ECE/TRANS/WP.29/GRE/2007/22
28 December 2006

REGULATION No. 48
(Installation of lighting and light-signalling devices)

Proposal for draft amendments to Regulation No. 48

Submitted by the expert from Japan

Figure 1

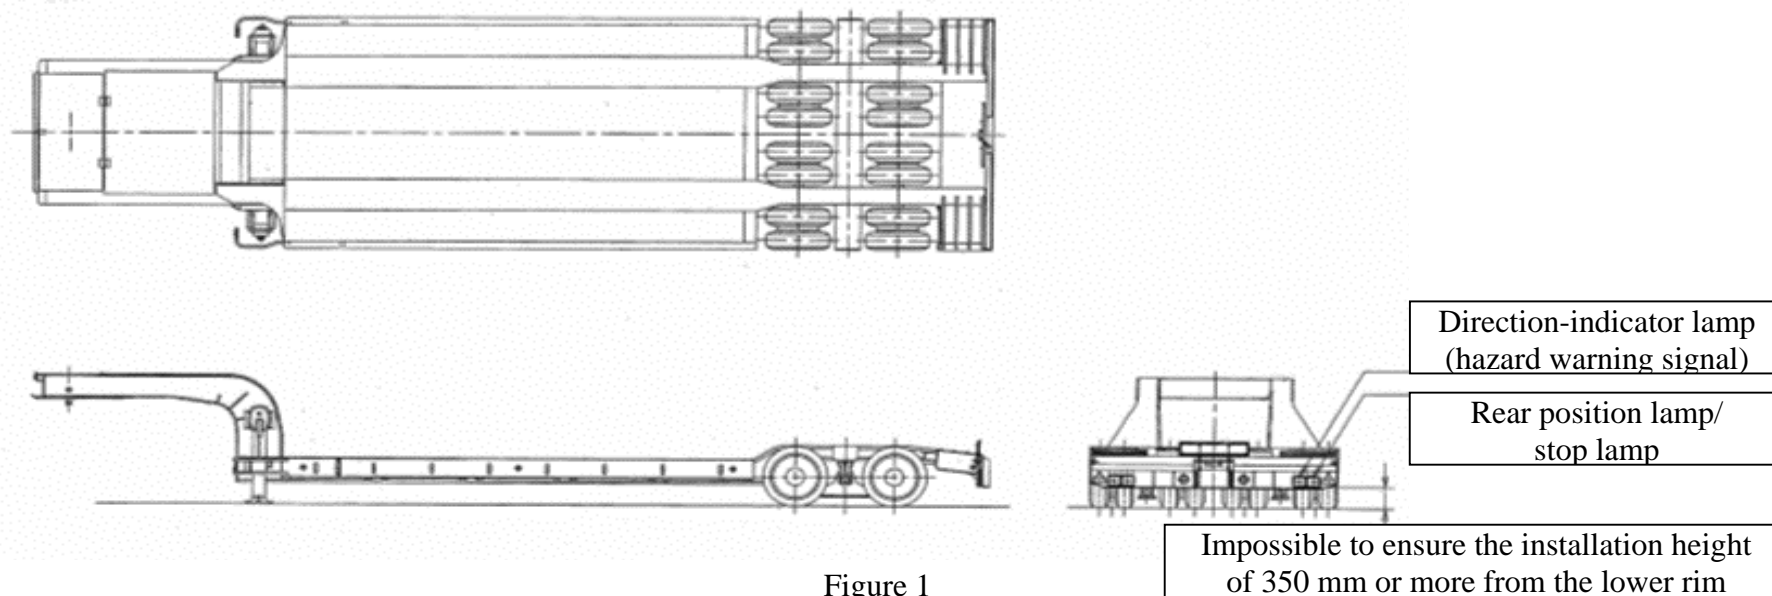
Figure 1 below shows that it is impossible to install side direction-indicator lamps (hazard warning signal), stop lamps and rear position lamps in a height of 350 mm or more from the lower rim.

In the case of low floor semi-trailers carrying heavy machinery vehicles, installation height requirement "350 mm or more" for side direction-indicator lamps, stop lamps and rear position lamps cannot be met. The reason is that such semi-trailers usually are equipped with a loading ramp for self-propelled installation of vehicles on it and the above-mentioned lamps can only be installed on the rear of the loading ramp.

Japan proposes that the minimal installation height of the above-mentioned lamps should be reduced to 250 mm or even more for vehicles that are equipped with a loading ramp for self-propelled installation from the back.

less than: 350 mm for M₁ and N₁ category of vehicles, and 500 mm for all other categories of vehicles, both measured from the lowest point (**250 mm in the case of semi-trailers if the shape of the bodywork makes it impossible to keep within 350 mm**); and

"**6.7.4.2.1.** For S1 or S2 categories devices: above the ground, not less than 350 mm (**250 mm in the case of semi-trailers if the shape of the bodywork makes it impossible to keep within 350 mm**) nor more than 1,500 mm (2,100 mm if the shape of the bodywork makes it impossible to keep within 1,500 mm and if the optional lamps are not installed).

"**6.10.4.2.** In height: above the ground, not less than 350 mm (**250 mm in the case of semi-trailers if the shape of the bodywork makes it impossible to keep within 350 mm**) nor more than 1,500 mm (2,100 mm if the shape of the bodywork makes it impossible to keep within 1,500 mm and if the optional lamps are not installed). If the optional lamps are installed, they shall be placed at a height compatible with the applicable requirements of paragraph 6.10.4.1., the symmetry of the lamps, and at a vertical distance as large as the shape of the bodywork makes it possible, but not less than 600 mm above the mandatory lamps."

Figure 2

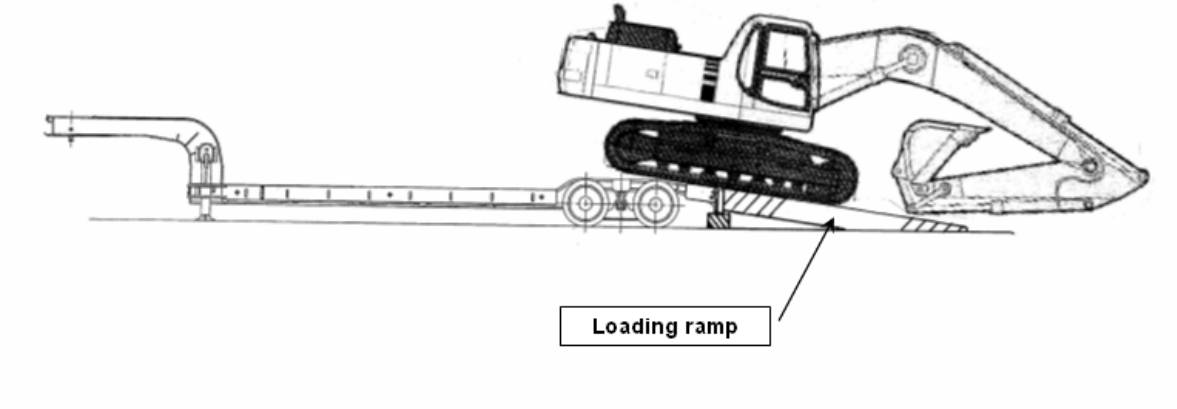
Figures 1 and 2 illustrate examples when installation of side direction indicator lamps (hazard warning signal), stop lamps and rear position lamps is not possible according to the current requirements.

Example of self-propelled installation of a heavy machinery vehicle onto the low floor semi-trailer using the loading ramp at the rear
